**NSLPP MEETING HELD ON 05/04/2023****Attachments:**

ADDRESS/WARD: 37 Bay View Street, McMahons Point**APPLICATION No:** 418/21**PROPOSAL:** Erection of dwelling house and associated works**PLANS REF:**

OWNER: P Dugal**APPLICANT:** P Dugal, C/- Architecture Saville Isaacs**AUTHOR:** Jim Davies, Executive Planner**DATE OF REPORT:** 23 March 2023**DATE LODGED:** 3 December 2022**RECOMMENDATION:** Deferred Commencement

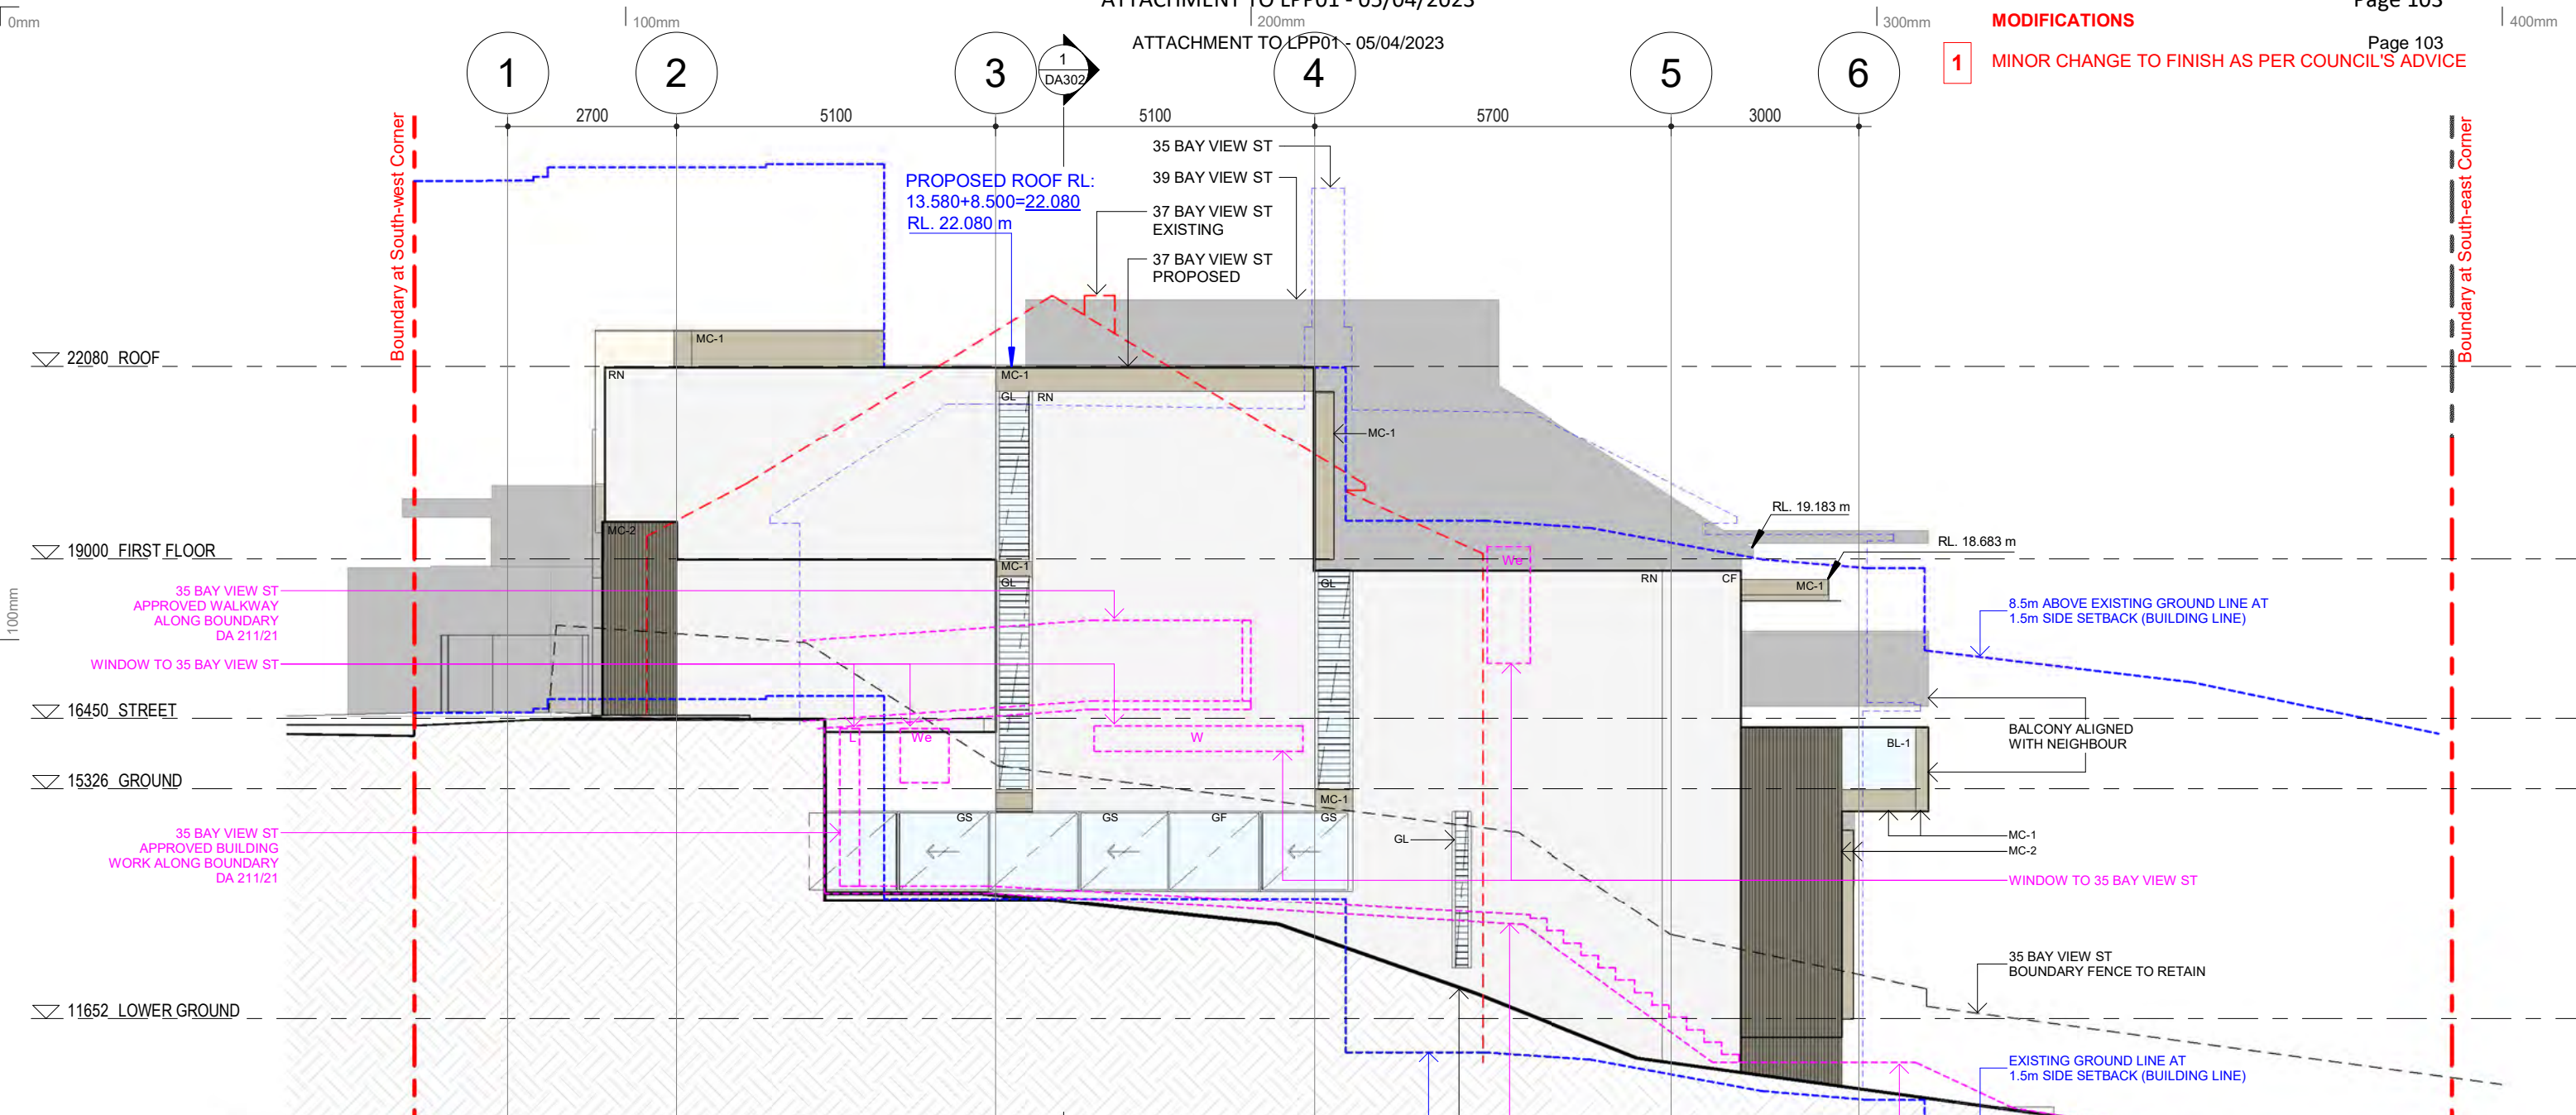
1 MODIFICATIONS
MINOR CHANGE TO FINISH AS PER COUNCIL'S ADVICE

**Shadow Impact to No.35 Bay View West Facade Windows ('Guest Bedroom', Non-Living area).
 Hourly Comparison between Existing and Proposed of No.37 Bay View.**

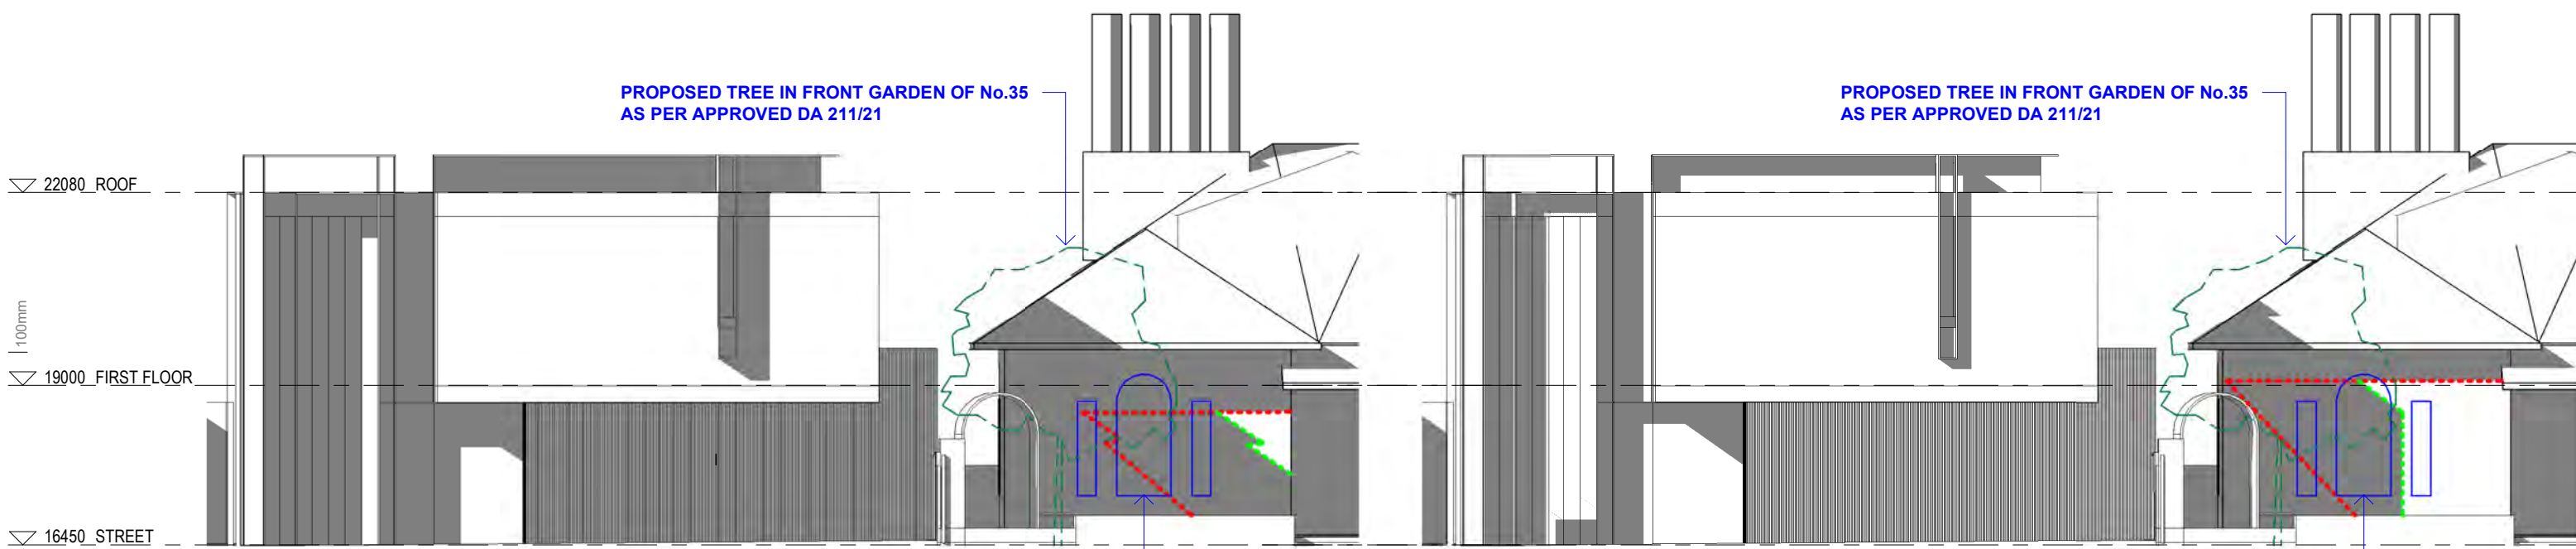
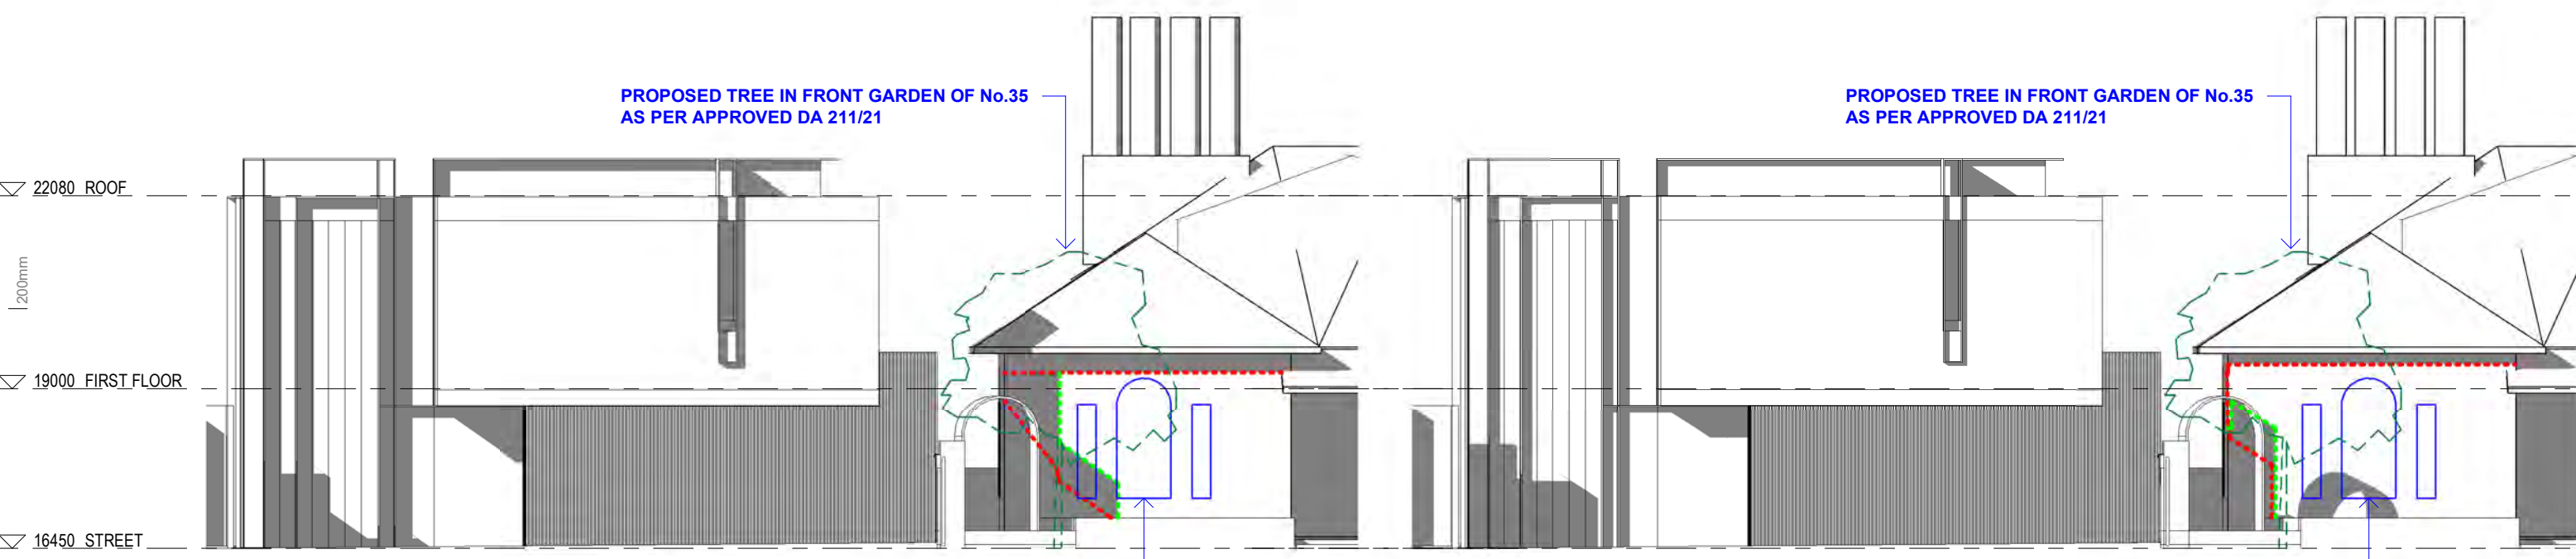
Although the shadow diagrams (plan and elevation) do not differentiate between which parts of the proposed building cause which part of the overshadowing, it is apparent that this impact would be reduced if the garage and first floor were to be respectively set back at least 900mm and 1.5m (the minima permitted). However, a 1.542m setback from the southern boundary, to have the same setback to the southern side boundary as the remainder of the building, is preferred as this would have streetscape and character, landscaping and further amenity benefits.

The applicant also submits the additional impact is reasonable as the bedroom in question is a 'guest' bedroom. This is considered to bear little weight, as the use of the room can readily and quickly change with the shifting demands of family/household life, or with change of ownership.

- d) Landscape the setback area between the garage and the southern boundary and, if agreed with the neighbour, erect a fence along the boundary.
 - e) Remove the roof garden and replace it with pebbles or similar to prevent access to the roof for all purposes except maintenance and repairs. Access for these purposes shall be provided by means other than directly from the bedroom.
